APPEAL SUMMARY

| Appeal ID: 20409 | Project Address: 621 SW Morrison St |

APPEAL INFORMATION SHEET

APPEAL DECISION**Key card operated emergency shear lock at egress door through adjacent tenant space: Granted as proposed.**

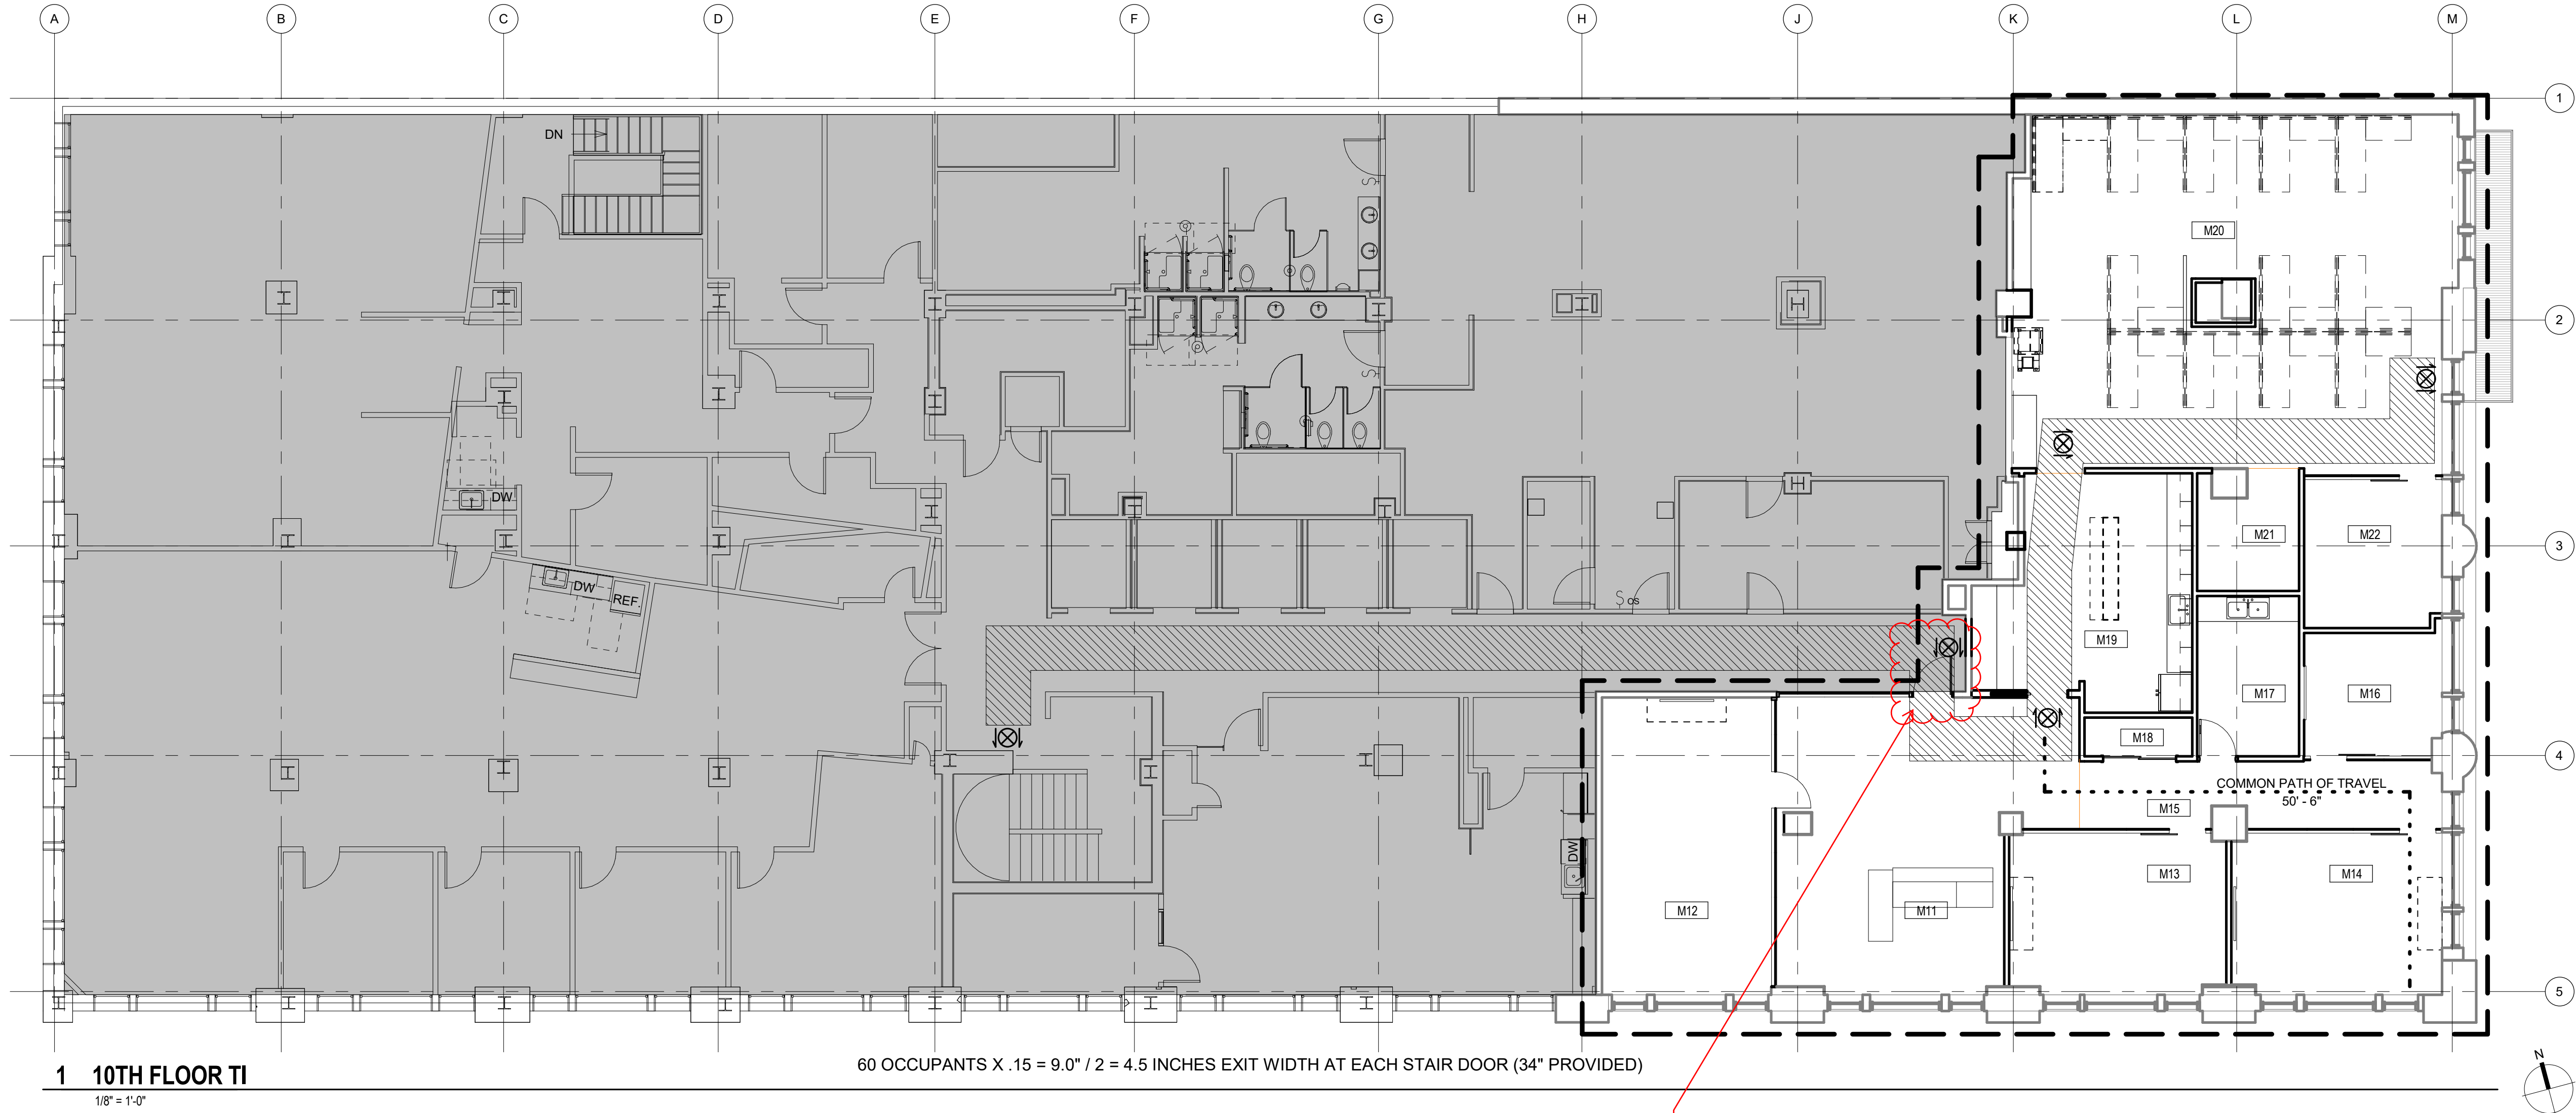
This is the door
scheduled to receive the
shear lock.

MEZZANINE PLAN

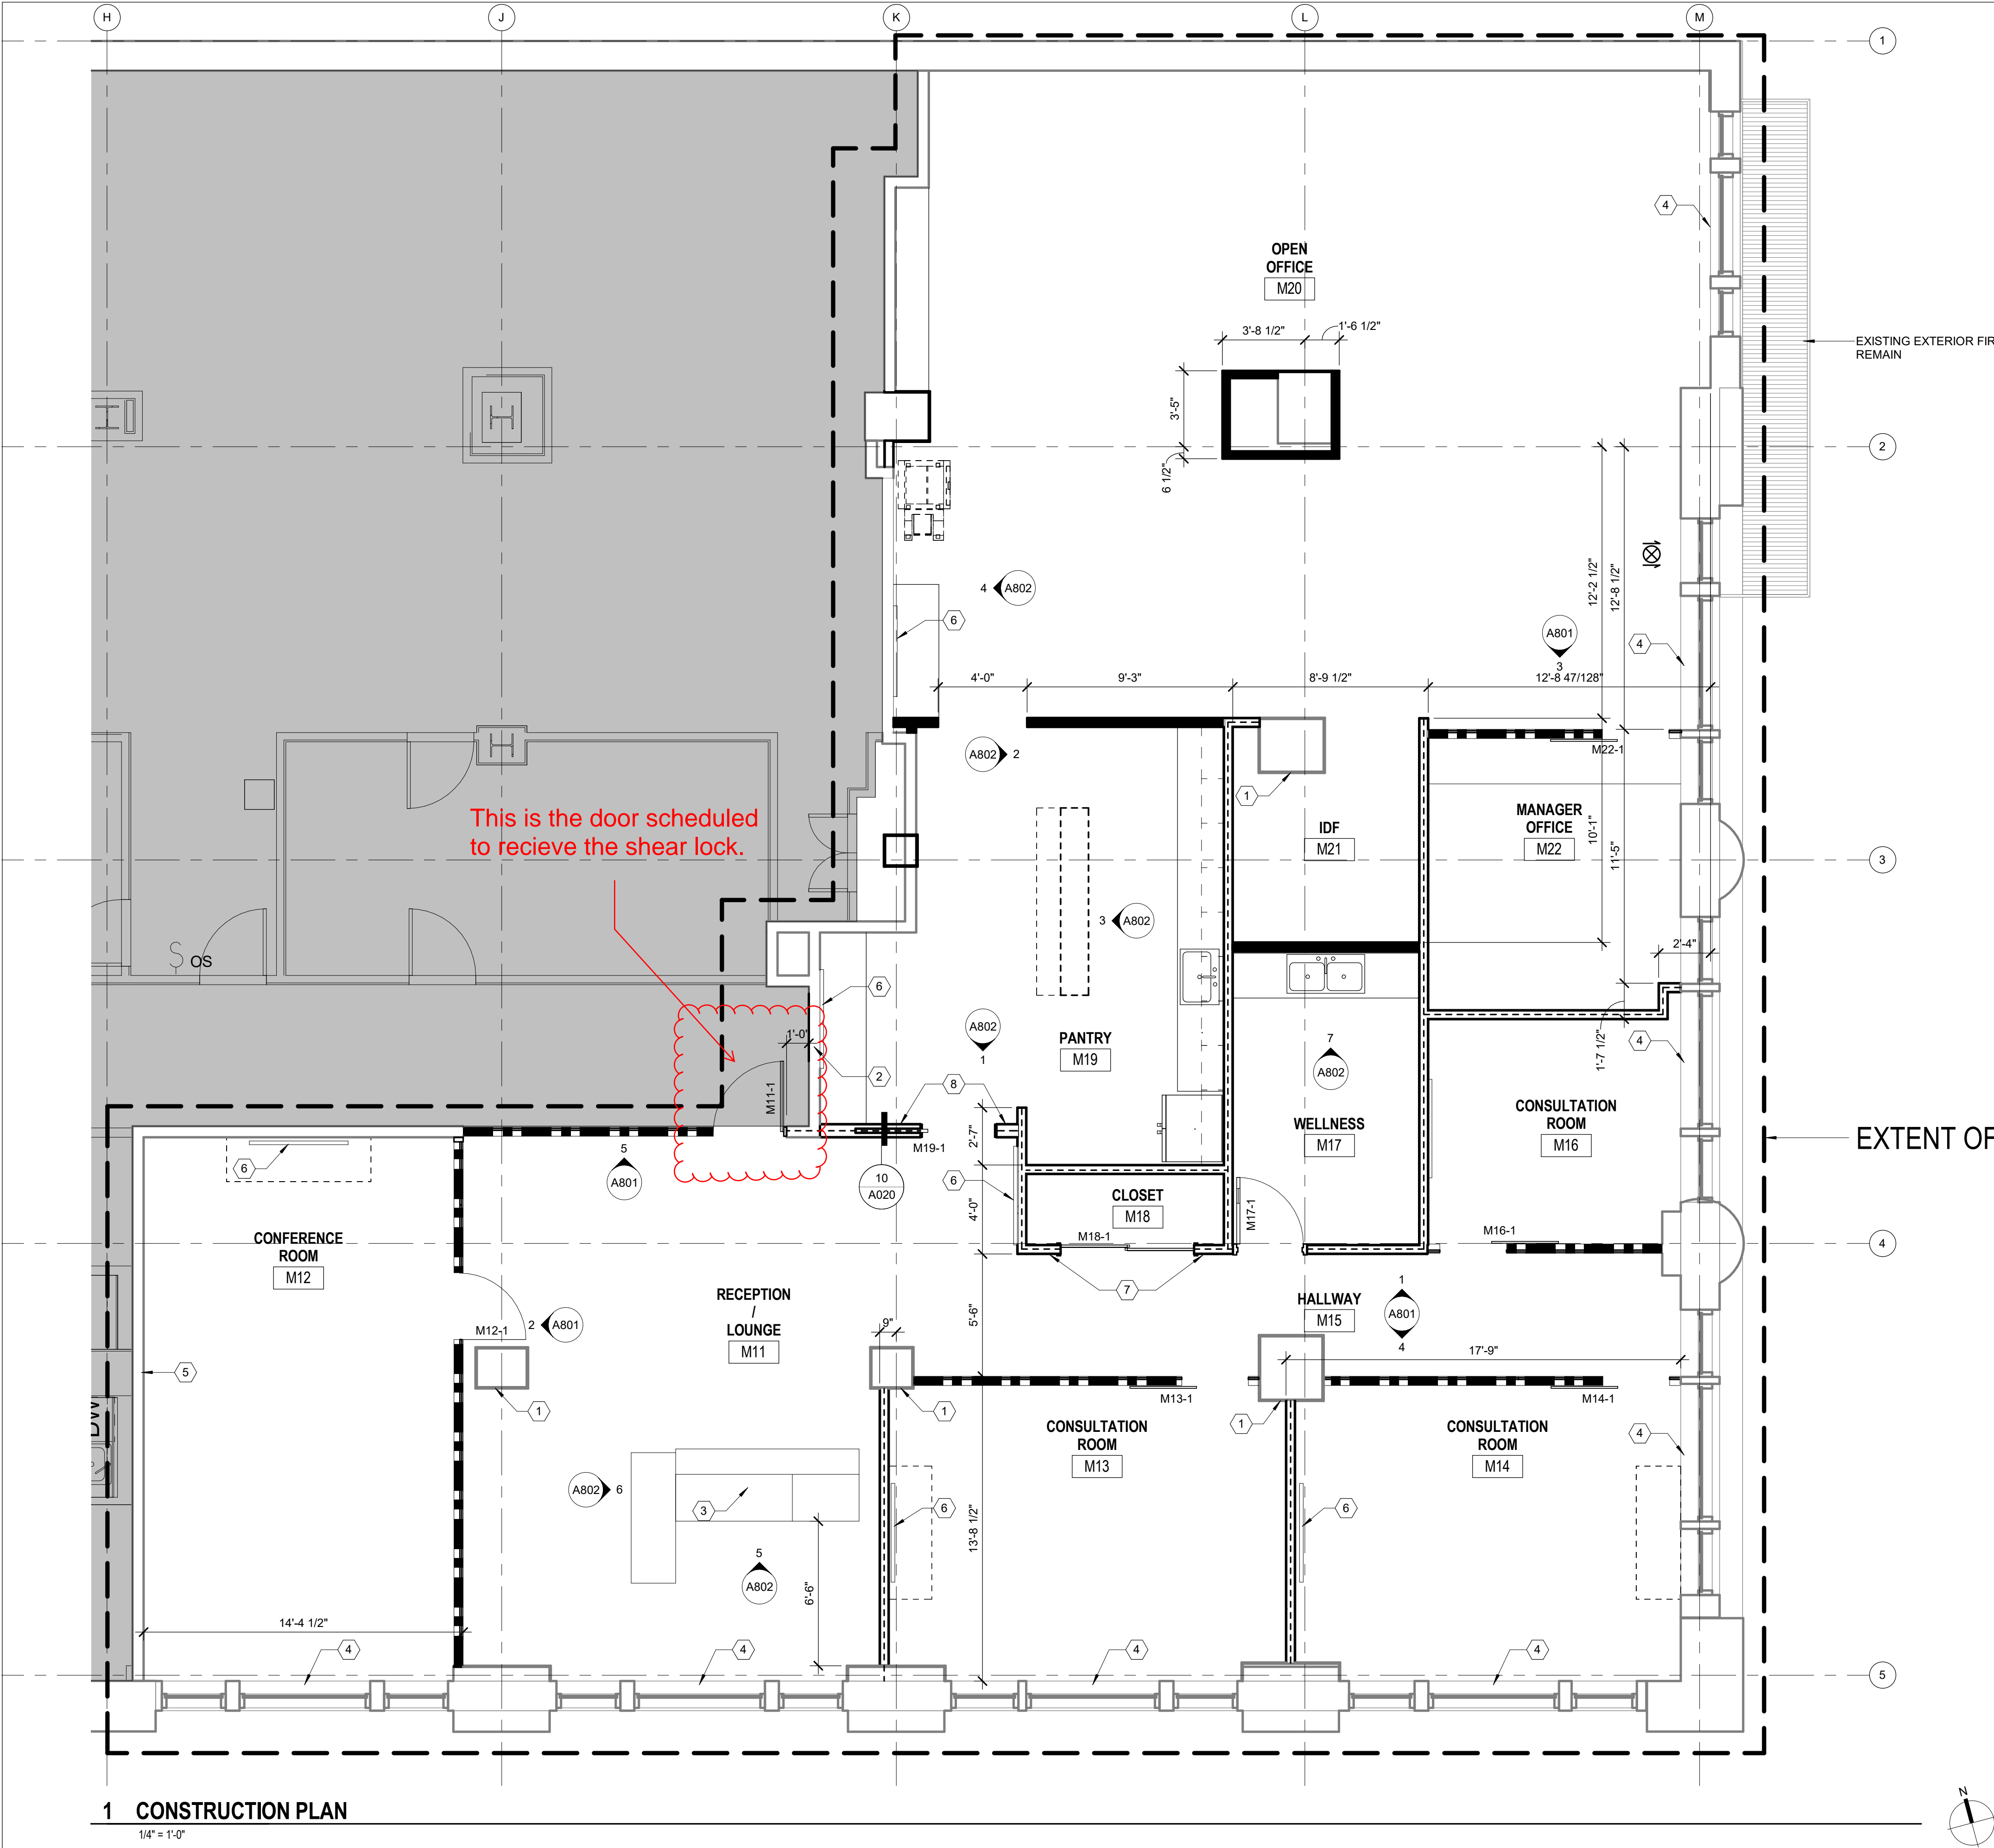
1. MEANS OF EGRESS, INCLUDING EXIT DISCHARGE, SHALL BE ILLUMINATED AT ALL TIMES.
2. PROVIDE FIRE ALARM PULL STATION AT HINGE SIDE OF THIS DOOR THAT DE-ACTIVATES THE ELECTRIC LOCK TO AN OPEN POSITION, THEREBY ALLOWING ACCESS TO THE EGRESS PATH TO EXTERIOR FIRE ESCAPE. SEE BUILDING APPEAL.
